Kings Canyon Road and Trailhead Project Public Comment and Responses

KING'S CANYON ROAD PARKING LOT LAYOUT

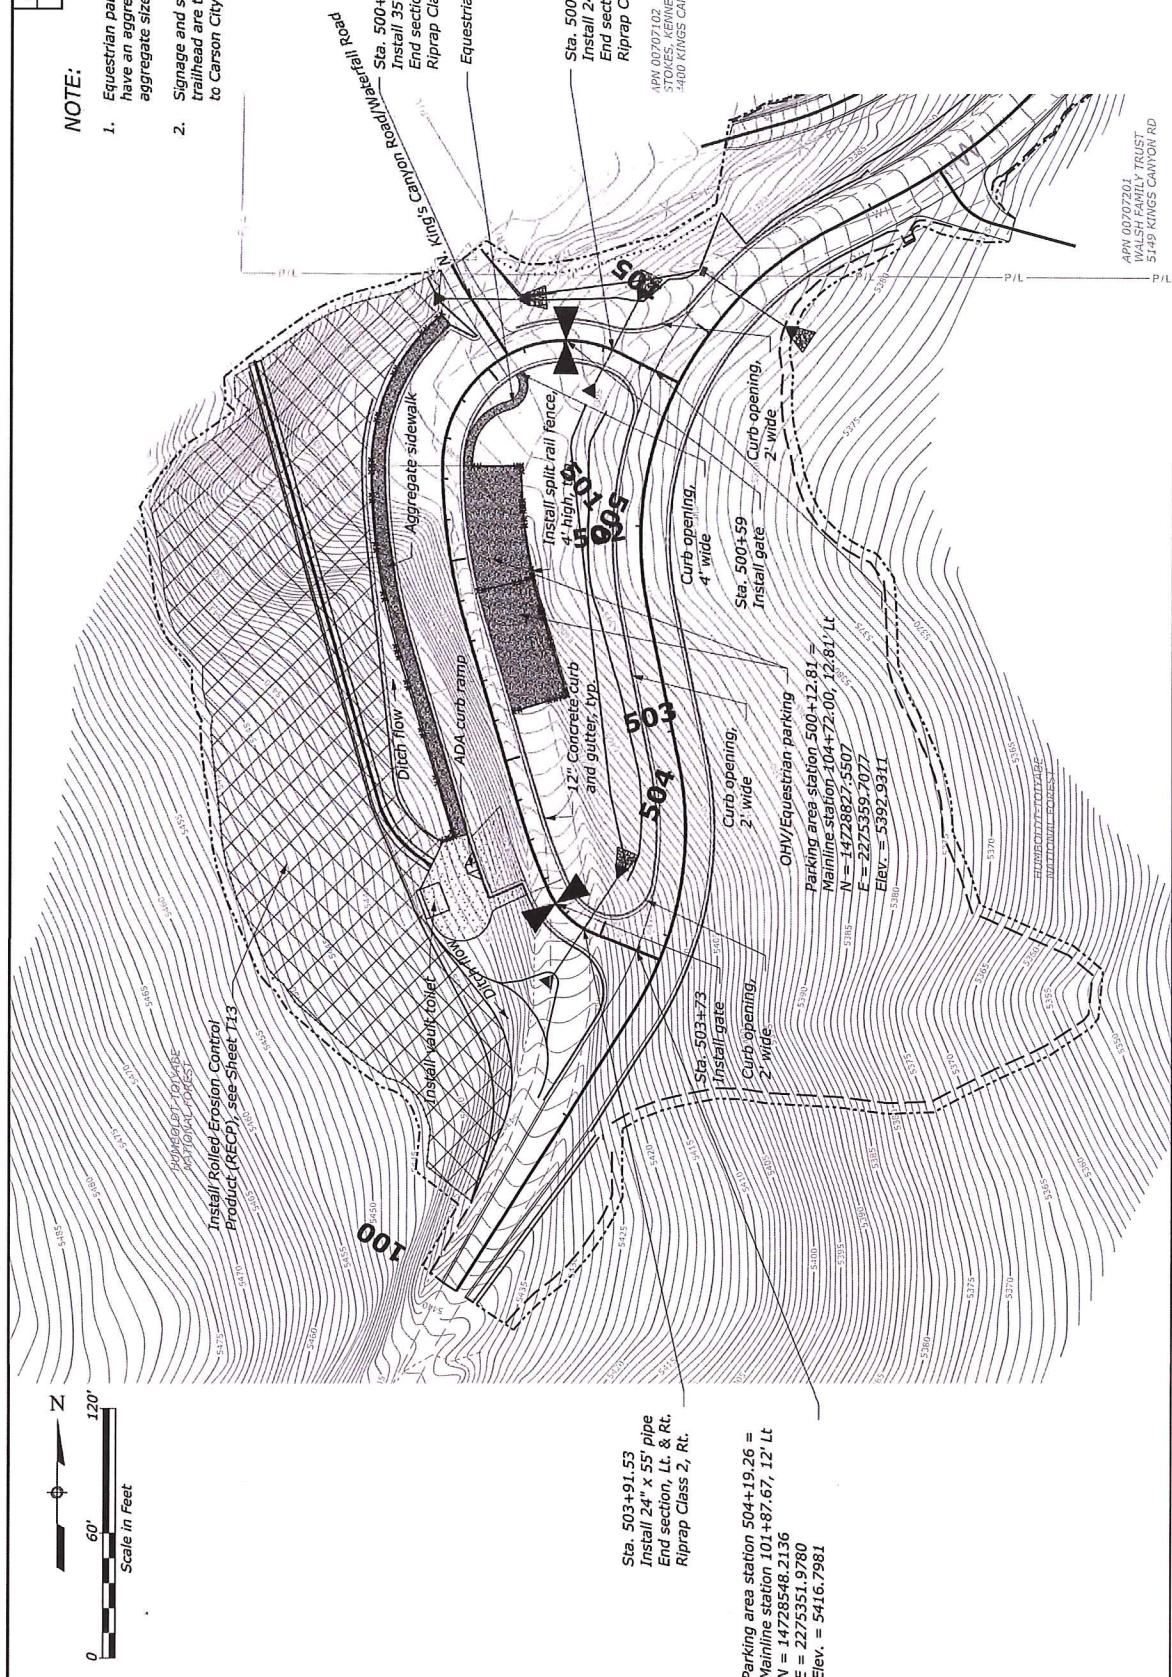
Parking Area	6	Move the trailhead parking area farther south into Forest Service land.	The location of the parking lot is extending to the south from its current location to accommodate additional parking area. The area will be within the jurisdiction of Carson City, allowing the City to enforce parking restrictions and limit nighttime uses through a management agreement with the US Forest Service. Currently, the City does not have an agreement with the US Forest Service and has limited enforcement power.
Parking Area	7	Prevent parking along the road for 1000 feet prior to the parking area with signage and tow-away zones to ensure access for emergency vehicles.	The City has coordinated with Central Federal Lands to include curbing, steeper roadside slopes, and additional "NO PARKING" signs along both sides Kings Canyon Road leading up to the parking area.
Parking Area	8	Make the trailhead parking lot one-way.	The City has coordinated with Central Federal Lands to refine the design, making the parking lot one-way.

Parking Area	9	The traffic controls are insufficient to support the current usage of the trail. Additional parking and perhaps other facilities are needed.	This project will improve the existing constraints at the trailhead by providing a designated parking area that allows for the management of vehicles, pedestrians, and emergency activities.
Parking Area	10	Once there is a formal parking lot, then please enforce no parking along the road.	Agreed. The Parks Department and the Sheriff's Office will work to enforce the planned 'NO PARKING' areas.
Parking Area	11	30 parking spaces is too many parking spaces for the trailhead parking area. People only park for a short time to visit the waterfall.	The number of parking spaces was based on typical observed and anticipated use of the existing trailhead area, prior to COVID-19. The parking area not only serves the Waterfall Trail, but also provides parking for other trails that start at this location as well as additional backcountry access into Forest Service public land. The revised design reduces the parking lot to approximately 25 parking spaces.

Parking Area	12	15 parking spaces is all that is needed.	Please see previous comment number 11 regarding the number of parking spaces.
Parking Area	13	Provide area for two trailers to park.	A parking area for OHV trailers or other trailers is being provided.
